## Gold Creek Pond modified alternative B

To date (July 2020) the USFS has proposed three alternatives for the restoration of Gold Creek pond; referred to as alternatives A, B and C. These alternatives can be found on the USFS's website. I support a modified alternative B as discussed here and as shown on the attached graphic.

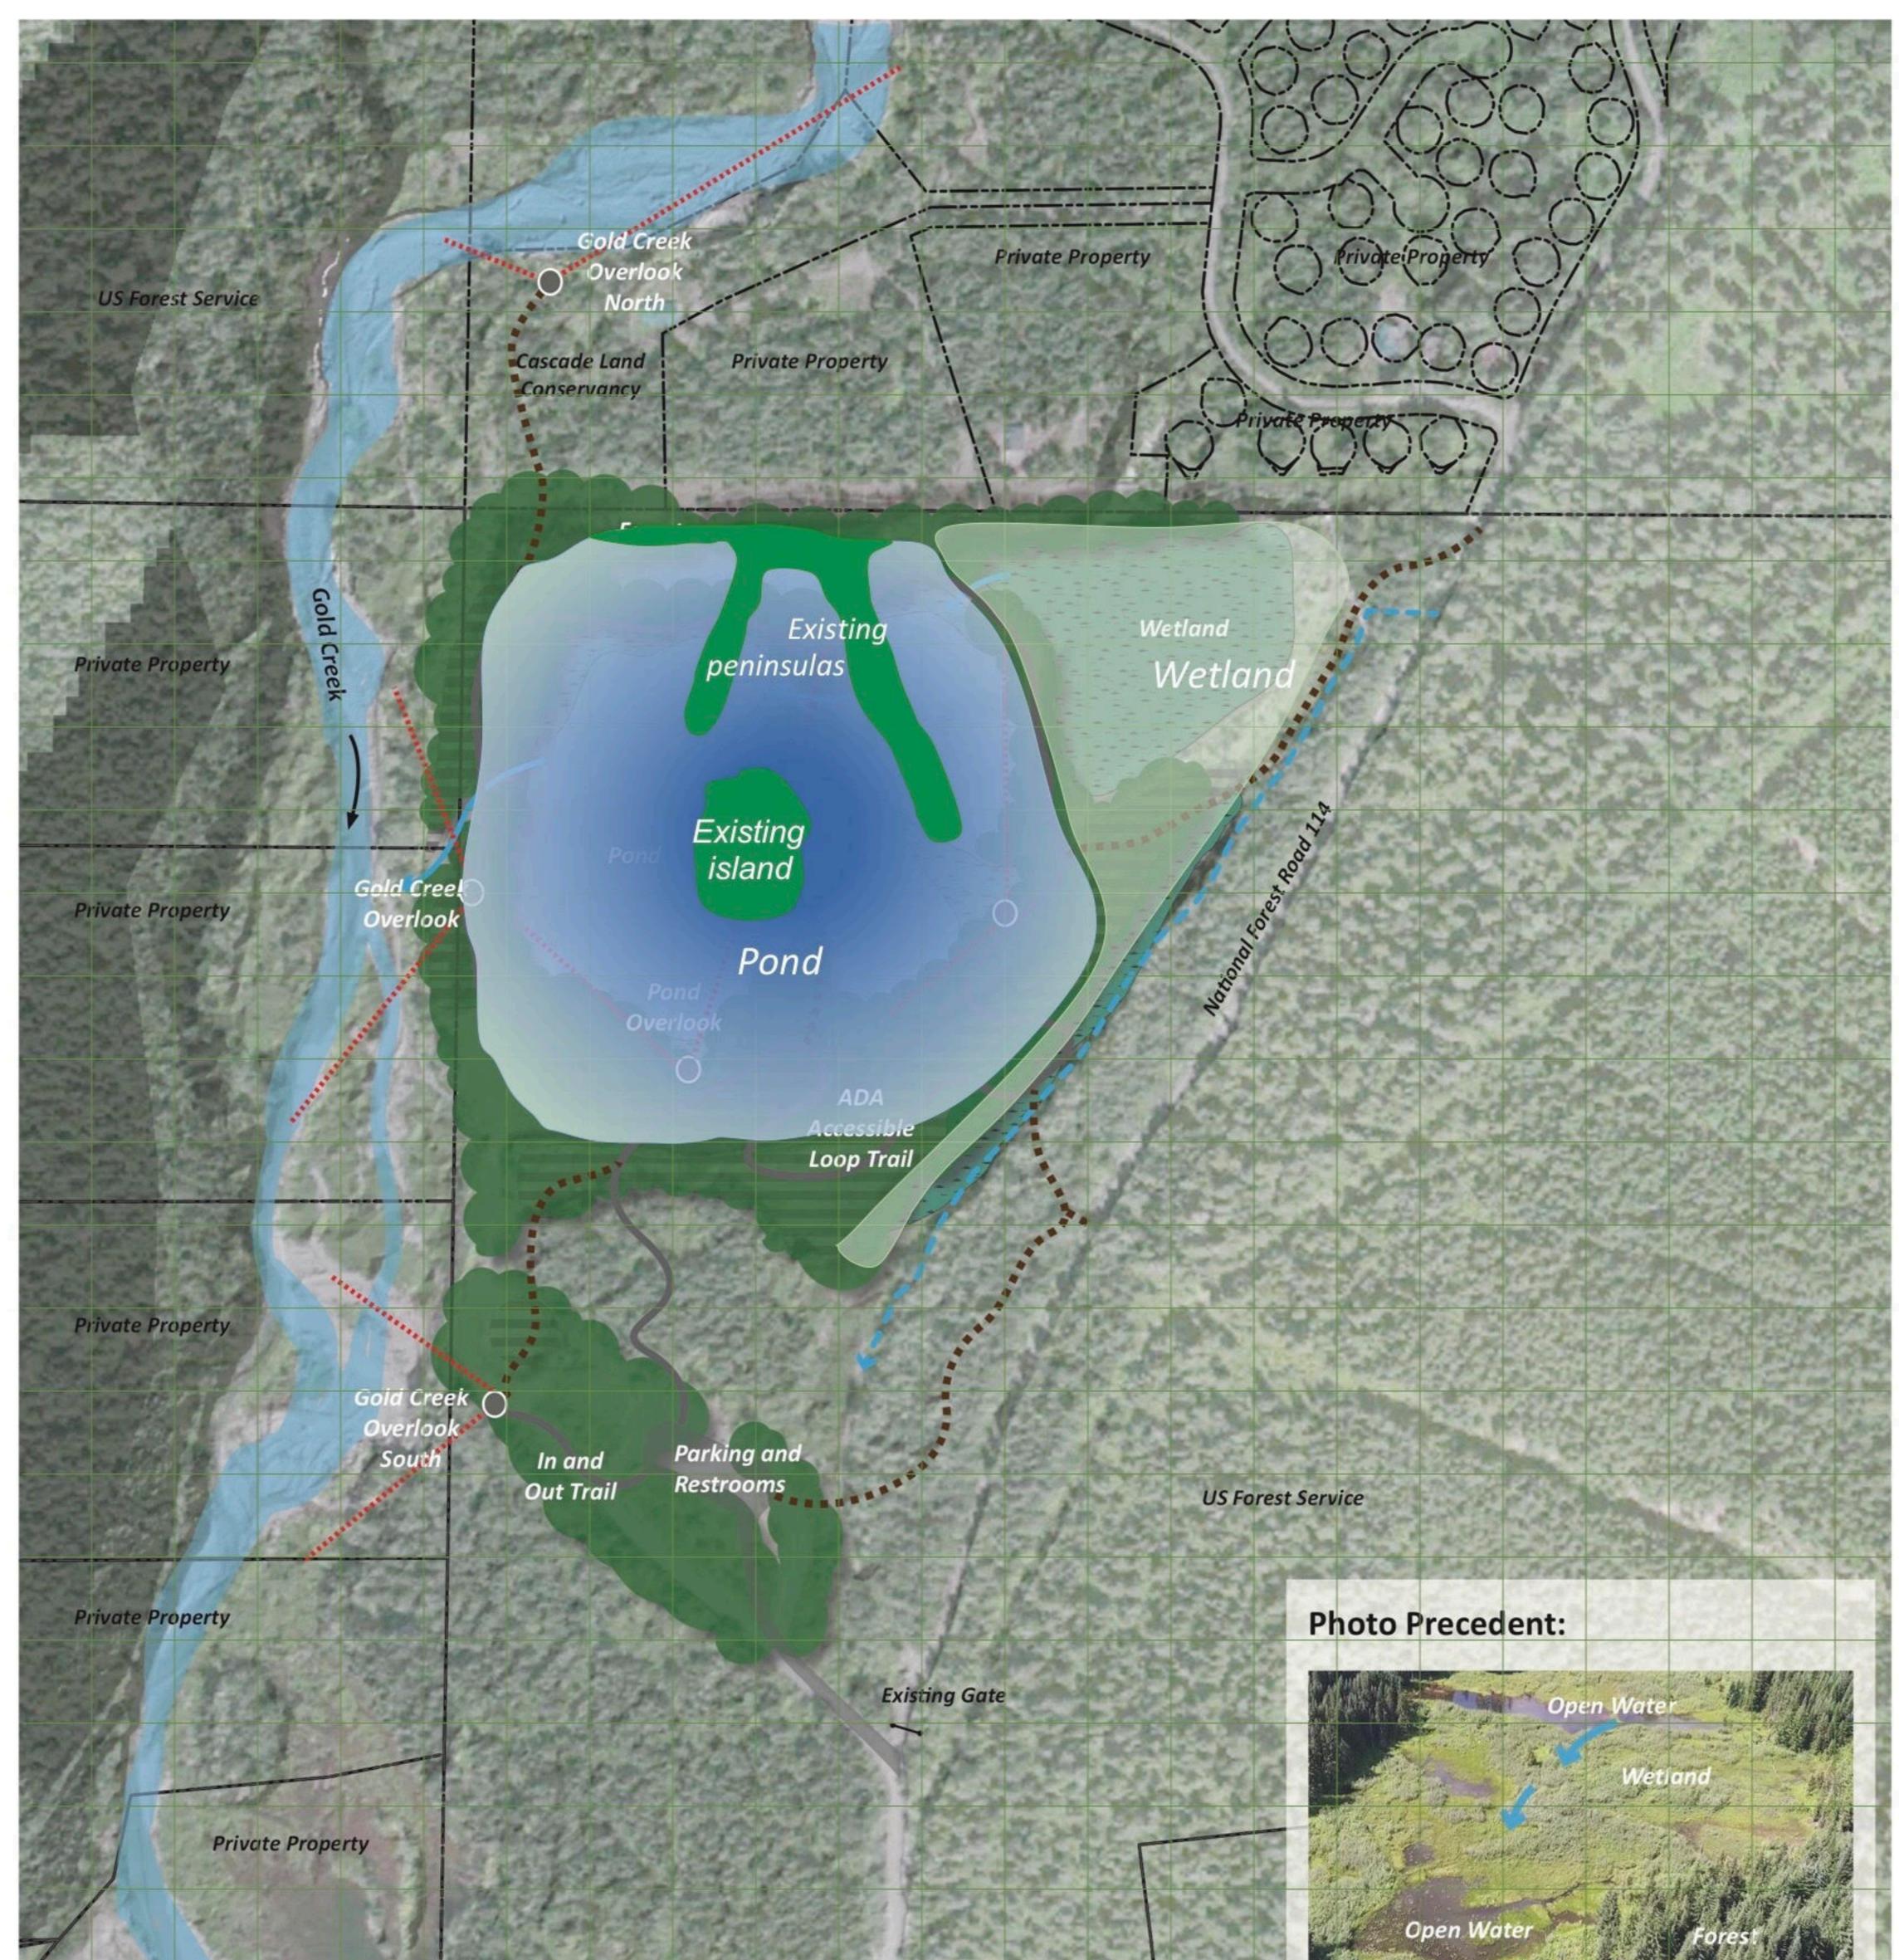
As mentioned, I support a modified alternative B plan. Key features of the modified plan compared to alternative B include leaving the pond's footprint essentially as it exists today (note below, that if it is shown that the pond lowers the groundwater and water in the stream, I propose raising the pond elevation to eliminate this effect). This proposed plan would not involve any fill material being placed in the pond, either to reduce the footprint or reduce the depth of the pond.

I concur with the plan to relocate the pond outlet to the westside of the pond. This relocated outlet flow would be directed into Gold Creek such that the outlet flow channel length would be minimal. Consideration should be given to raising the pond surface elevation if it can be determined that the pond is lowering the groundwater table in the immediate vicinity of the pond. This could be accomplished by a flow control structure at the outlet.

I propose enhancing the existing low-class wetland on the northeast side of the pond and constructing wetlands on the east side of the pond where the current pond outflow channel is, creating a continuous wetland on the east side of the pond.

Topsoil and soil amendment would be brought in and placed around the area bordering the pond. Native plants would figure prominently in this area.

Other features related to the modified plan B include relocating the Starwater storm drainage system so that it discharges into Gold Creek, assuming that the function of the storm drainage system is not degraded as a result of relocation. The parking capacity would remain as it is today. Finally, Heli's pond should remain in its current state.
